SUBJECT: AMENDMENT NO. 108 TO FACILITY OPERATING LICENSE NO. DPR-43
(TAC NOS. M77357 AND M77427)

KEWAUNEE NUCLEAR POWER PLANT

ATTACHMENT TO LICENSE AMENDMENT NO. 108

**FIGURE TS 3.1-4
 LOW TEMPERATURE OVERPRESSURE PROTECTION CURVE
 APPLICABLE FOR PERIODS UP TO END OF OPERATING CYCLE 20**

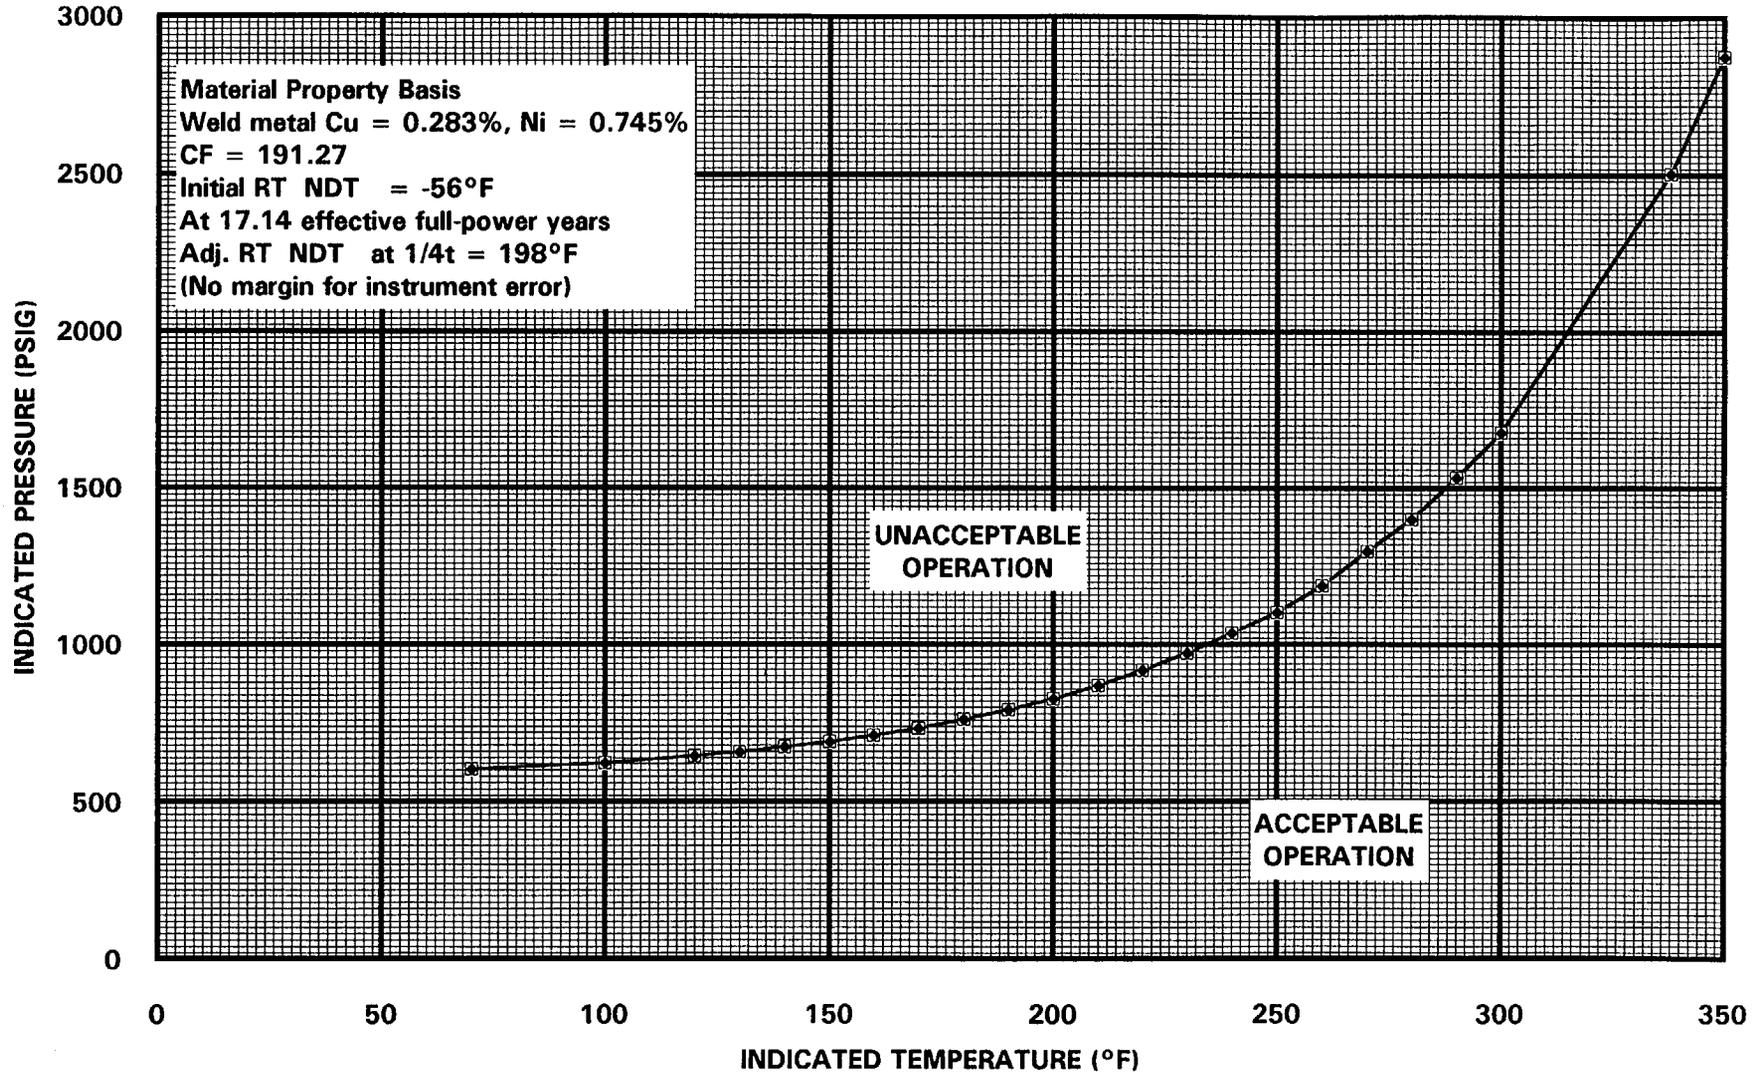
1. Figure TS 3.1-4 will be added to define 10 CFR 50 Appendix G pressure and temperature limitations for LTOP evaluation through the end of operating cycle (EOC) 20. This is equivalent to 17.14 effective full power years.
2. Figure TS 3.1-4 will be used to evaluate LTOP events when RCS temperature is less than or equal to the enable temperature of 338 degrees F.
3. Existing TS 3.1.b.1 will be modified to reflect the incorporation and use of Figure TS 3.1-4.

The text of the existing TS 3.1.b.1 has been modified to reflect the incorporation and use of Figure TS 3.1-4. The figure is to be used for evaluation of reactor vessel integrity should an LTOP event occur. Compliance with the pressure and temperature limits of Figure TS 3.1-4 provides assurance that adequate reactor vessel fracture toughness properties are maintained, and assure the integrity of the RCS pressure boundary.

As proposed, Figure TS 3.1-4 expires at EOC 20, which is equivalent to 17.14 EFPY of operation. EOC 20 is currently scheduled to occur about April 1995. Without further action by the licensee, LTOP events occurring after EOC 20 would be evaluated to the zero cooldown rate curve of Figure TS 3.1-2.

The staff has reviewed the licensee's proposal to add the LTOP design curve, Figure TS 3.1-4, to the TS, and finds it acceptable.
